HUDSON LOGISTICS CENTER

SP #12-22

Staff Report #4

From the Site Plan Application: Proposed redevelopment of Property for a warehouse and distribution facility, representing a reduction of the scope of the approved Hudson Logistics Center originally approved by Site Plan Decision (SP #04-20) issued on May 5, 2021 for redevelopment of three (3) buildings having a footprint collectively consisting of 2,614,984 s.f., to a single building having a footprint of approximately 1,393,822 s.f. for warehouse, distribution, and associated uses and structures on a single 375.37-acre lot, along with access driveways, parking, stormwater/drainage, and other utility infrastructure, along with lighting, landscaping and other improvements shown on the plans.

MATCHLINE AT STATION 20+00
SEE SHEET CU217

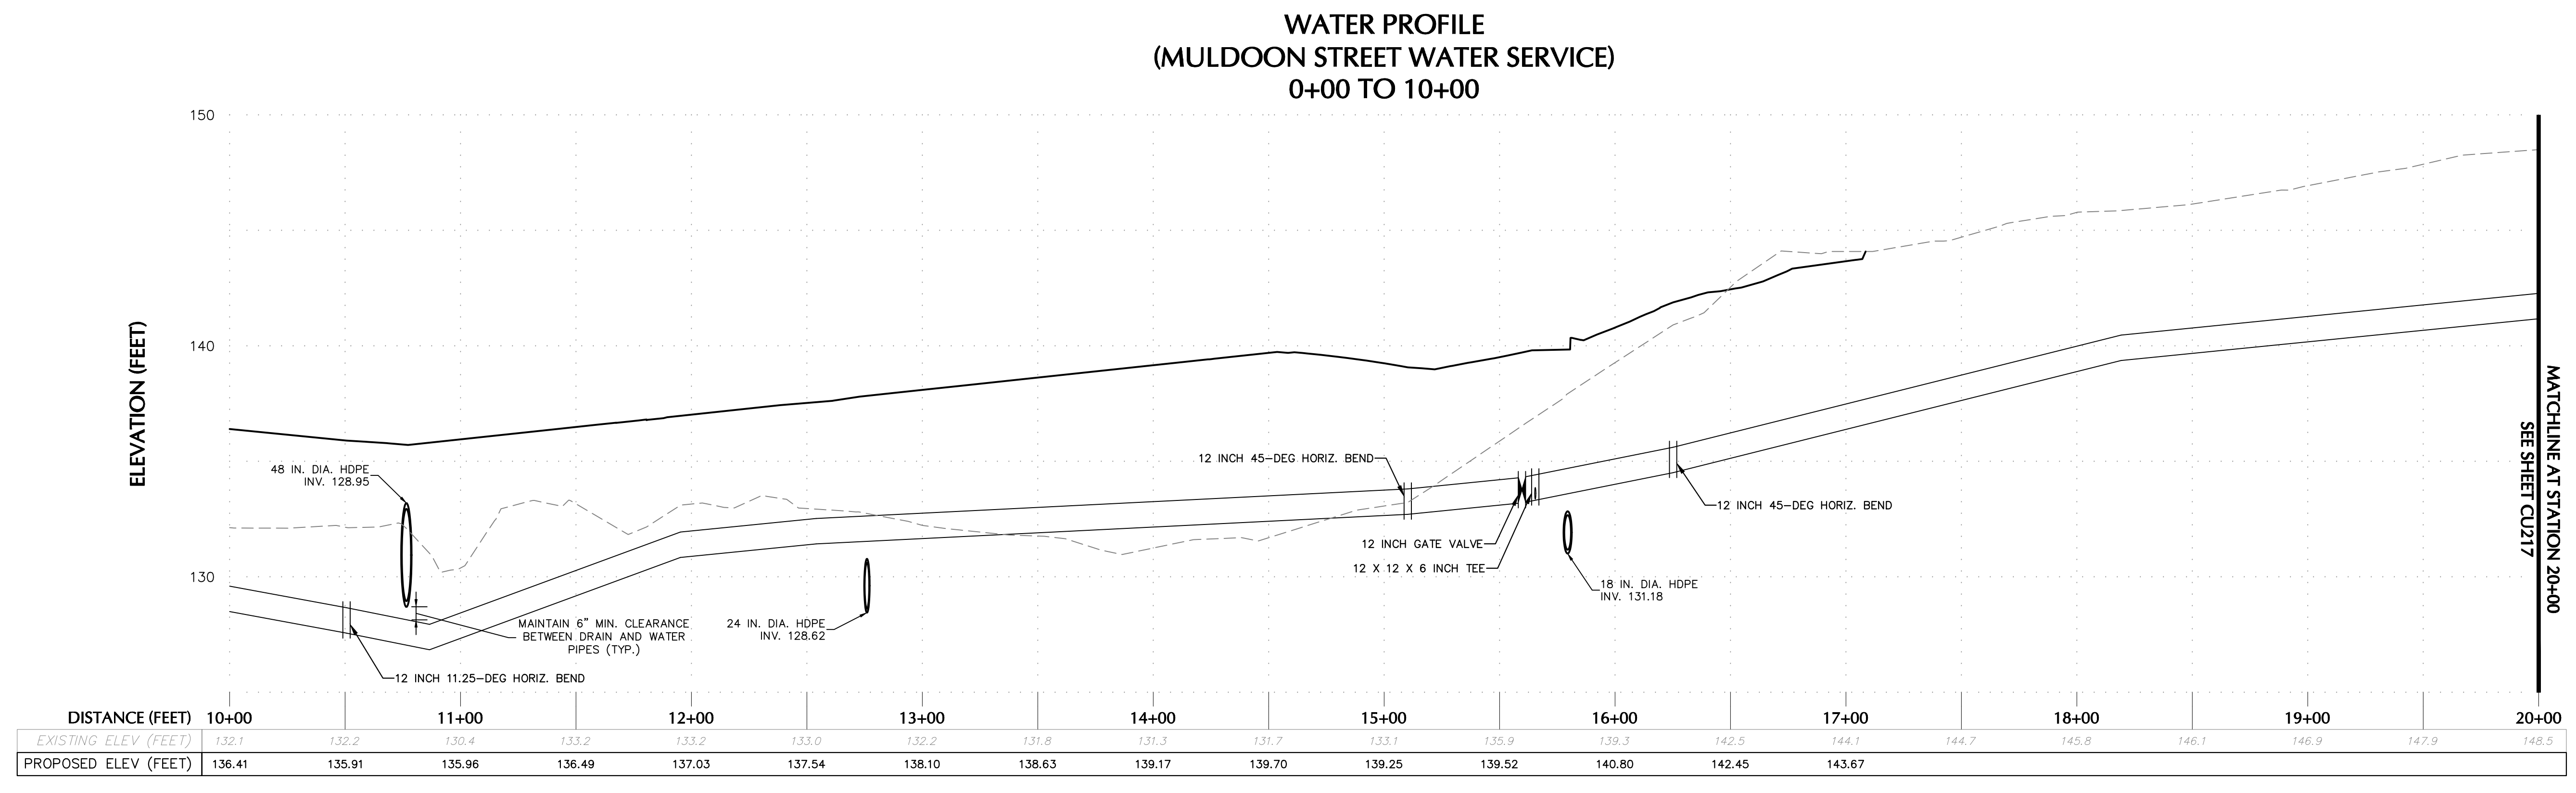
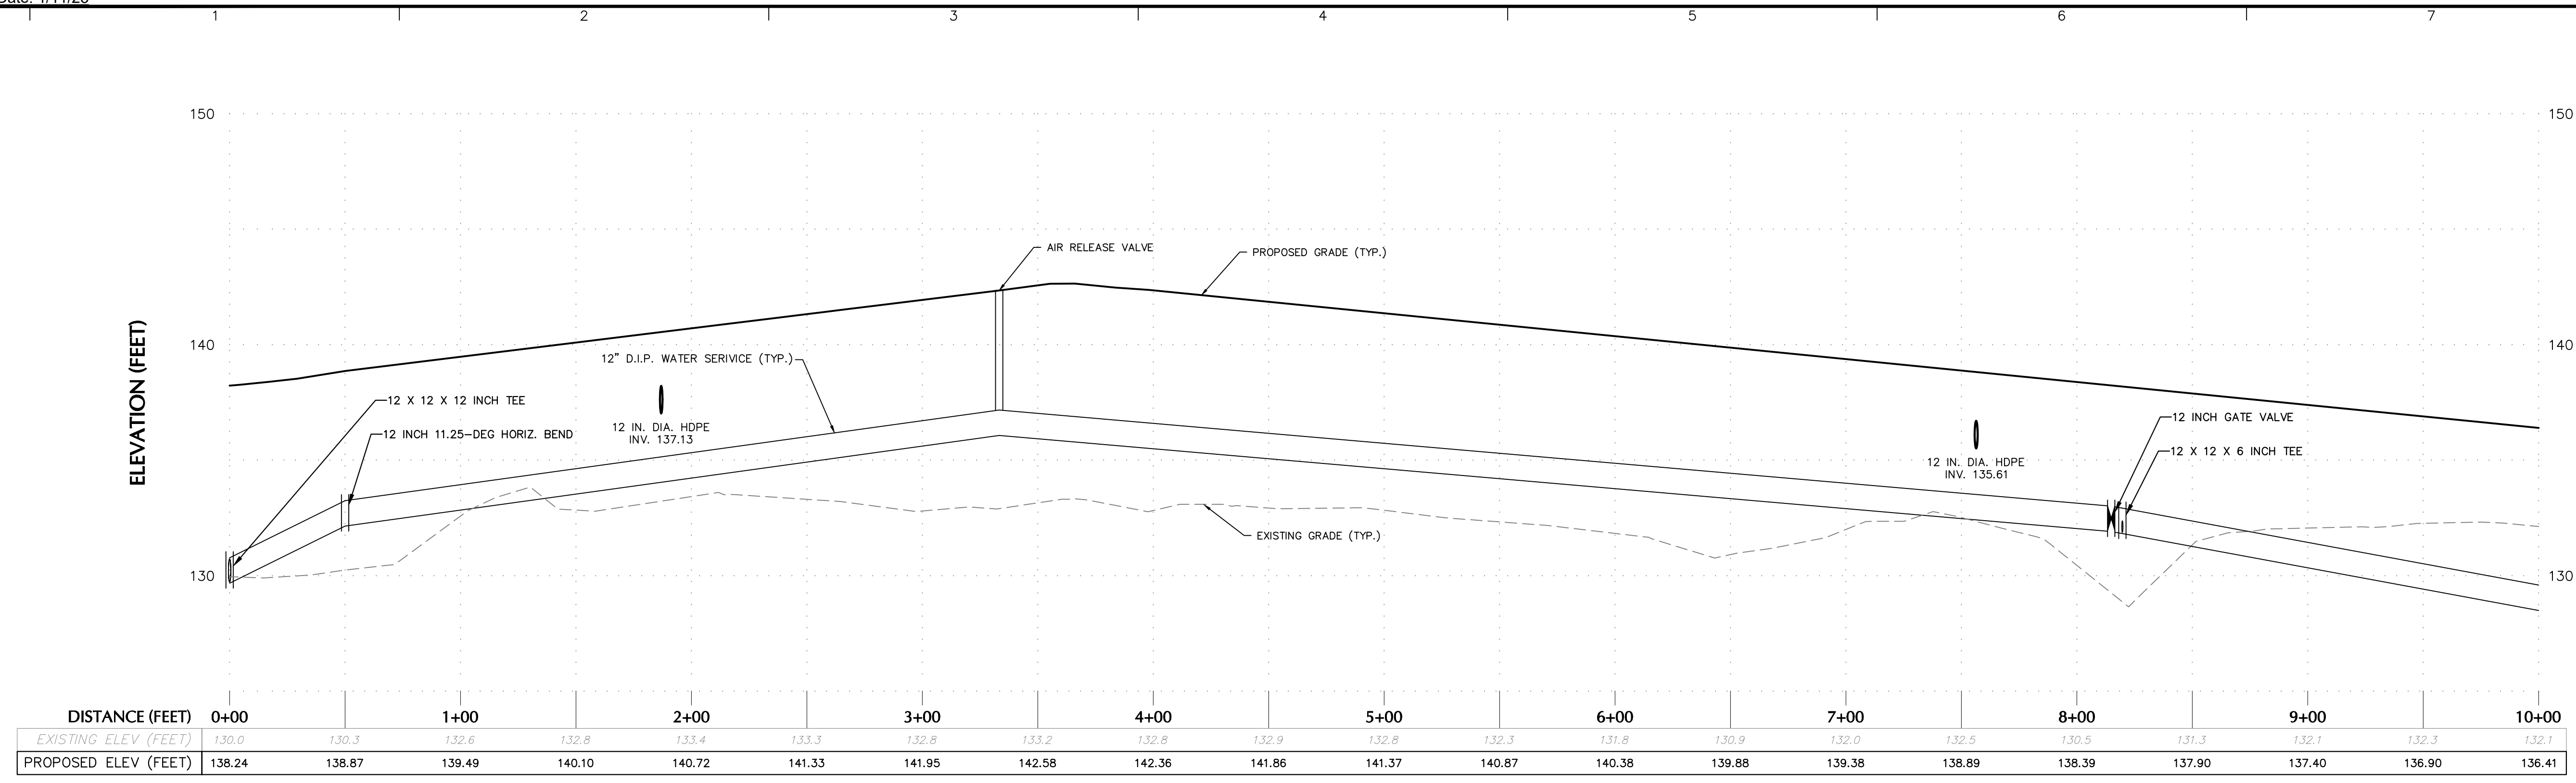
SHEET CU216 – MULDOON STREET SERVICE WATER PROFILE

LANGAN COMMENT RESPONSE: An air release valve has been added at this location. See the attached drawings CU112 and CU216 for reference.

LANGAN COMMENT RESPONSE: The profile has been edited as suggested. See the attached drawing CU216.

**WATER PROFILE
(MULDOON STREET WATER SERVICE)
20+00 TO 27+00**

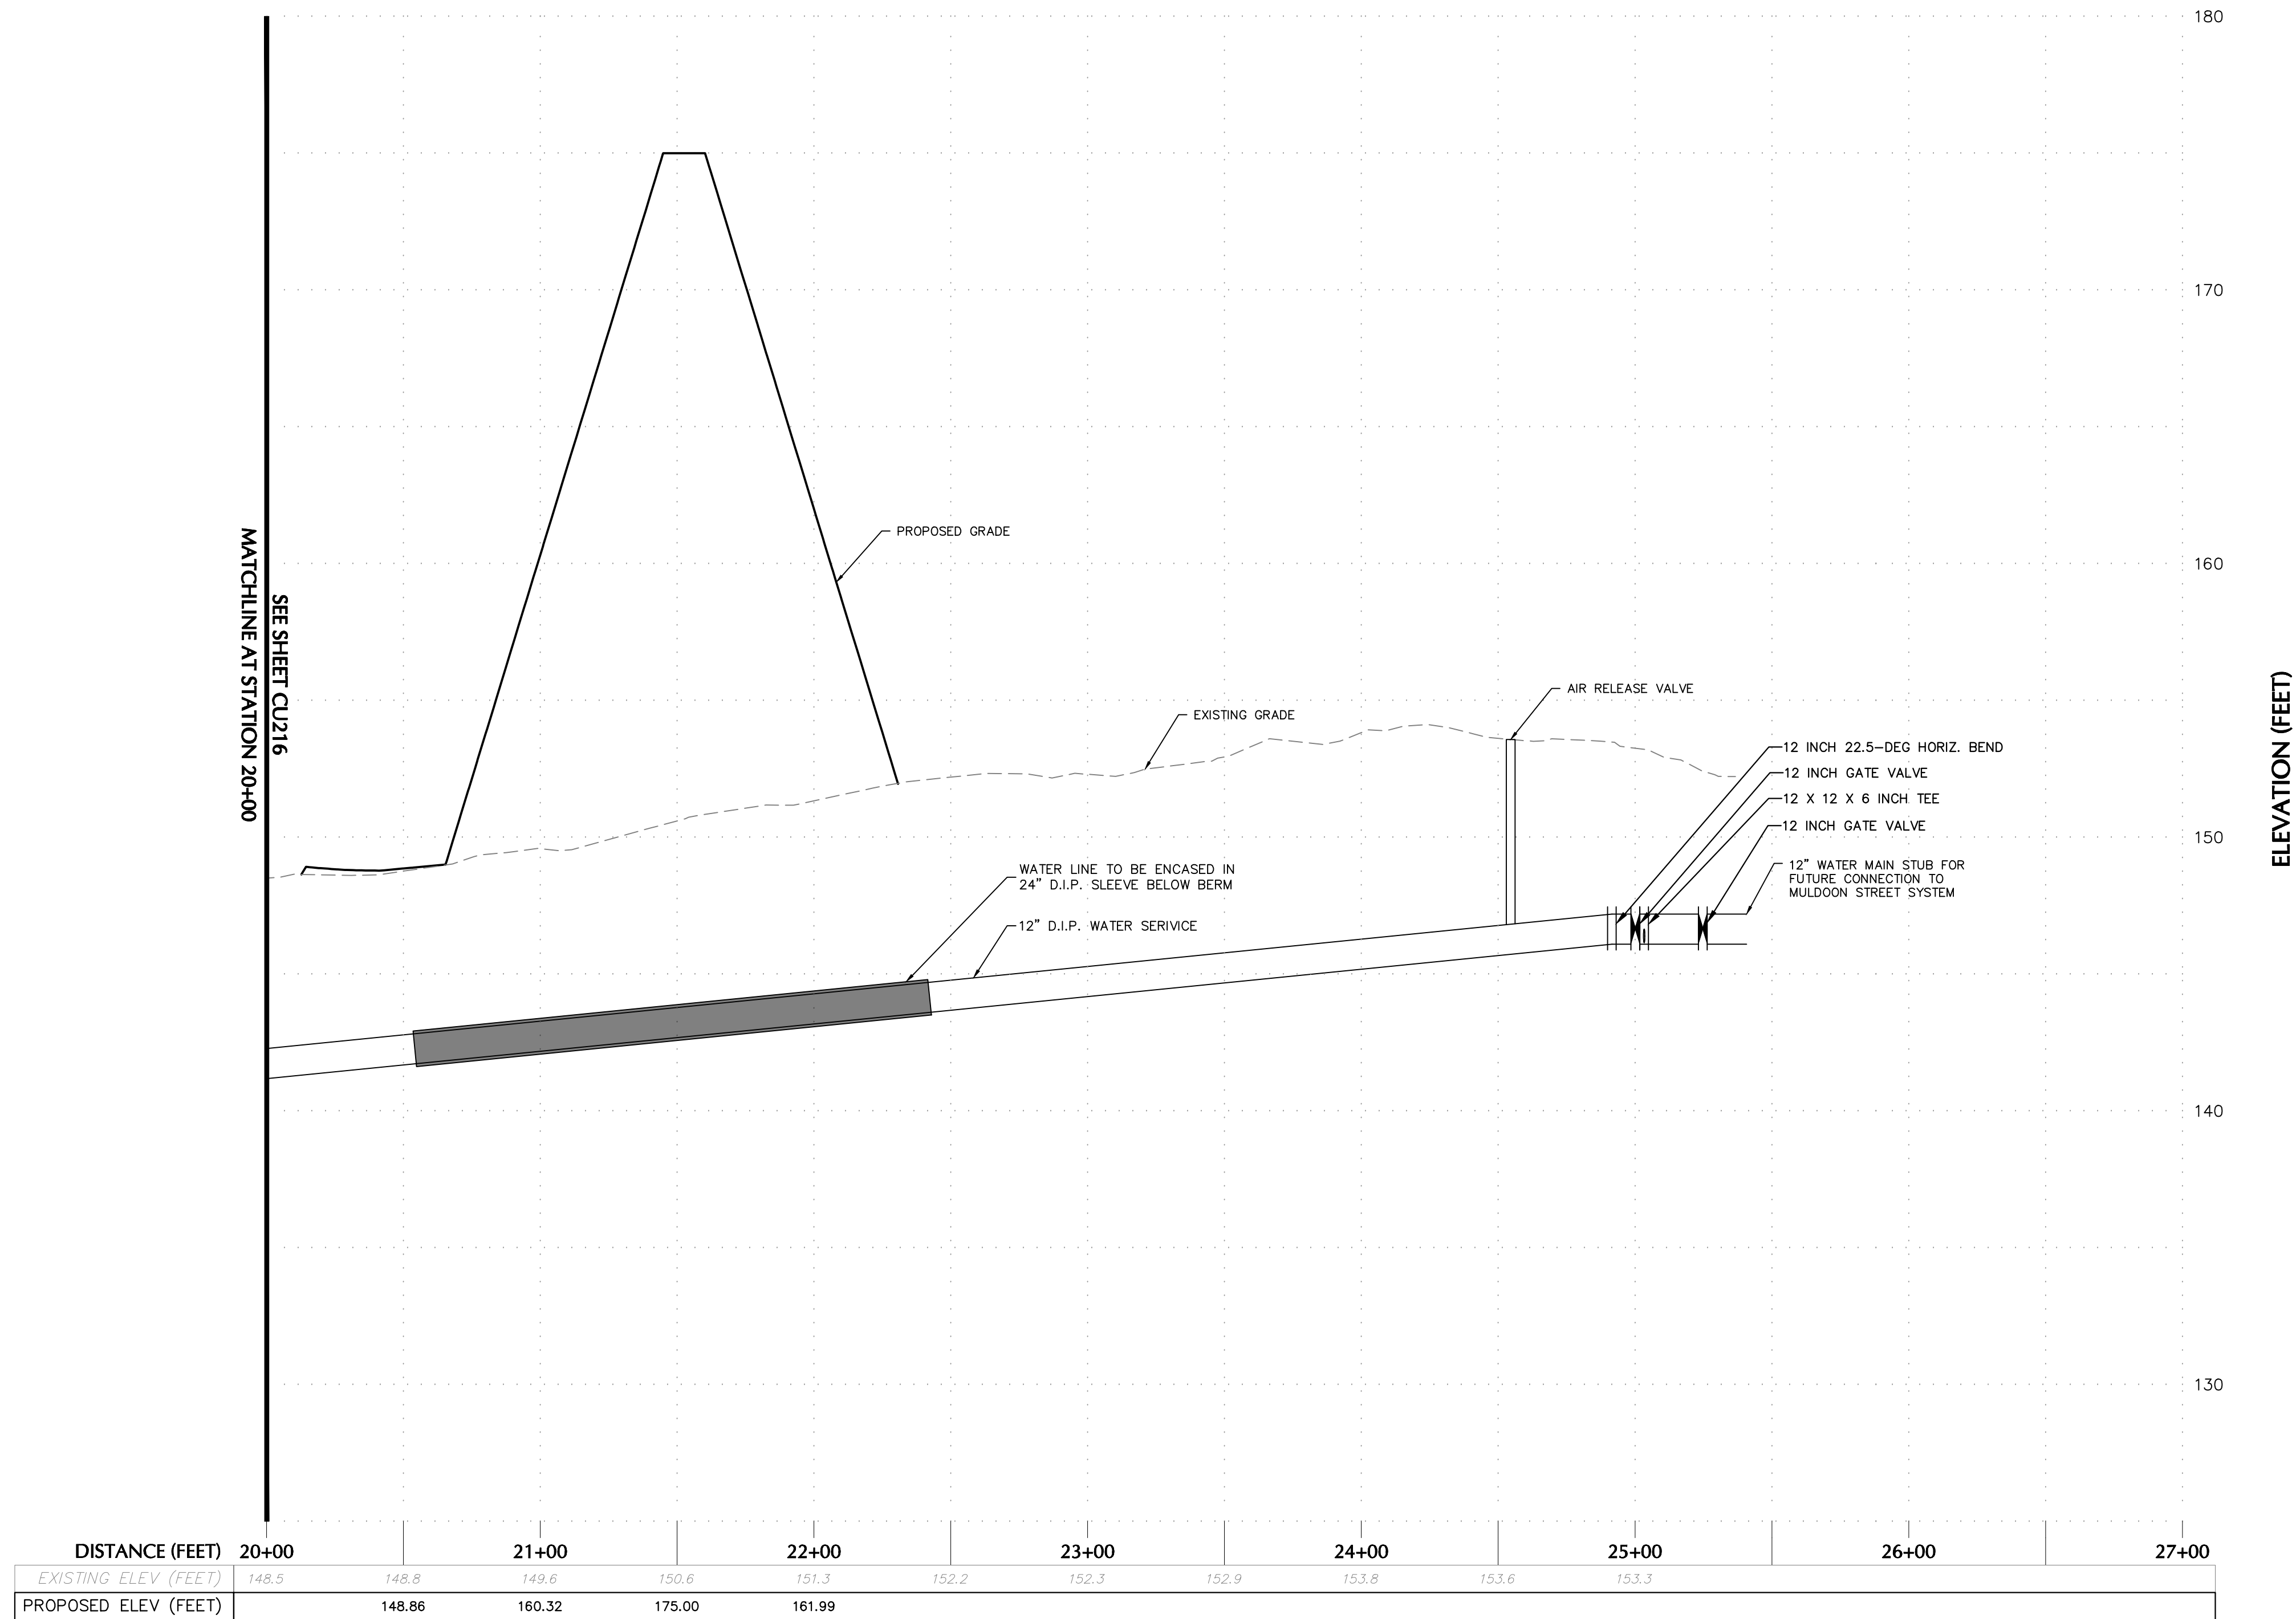
- Weston & Sampson Comment: Show water main encased in steel per plan Sheet CU120.

LANGAN COMMENT RESPONSE: The attached drawing CU217 has been revised to show steel pipe encasement around the water main.

LANGAN COMMENT RESPONSE: The revised drawings CU120 and CU217 show an air release valve at this location as suggested.
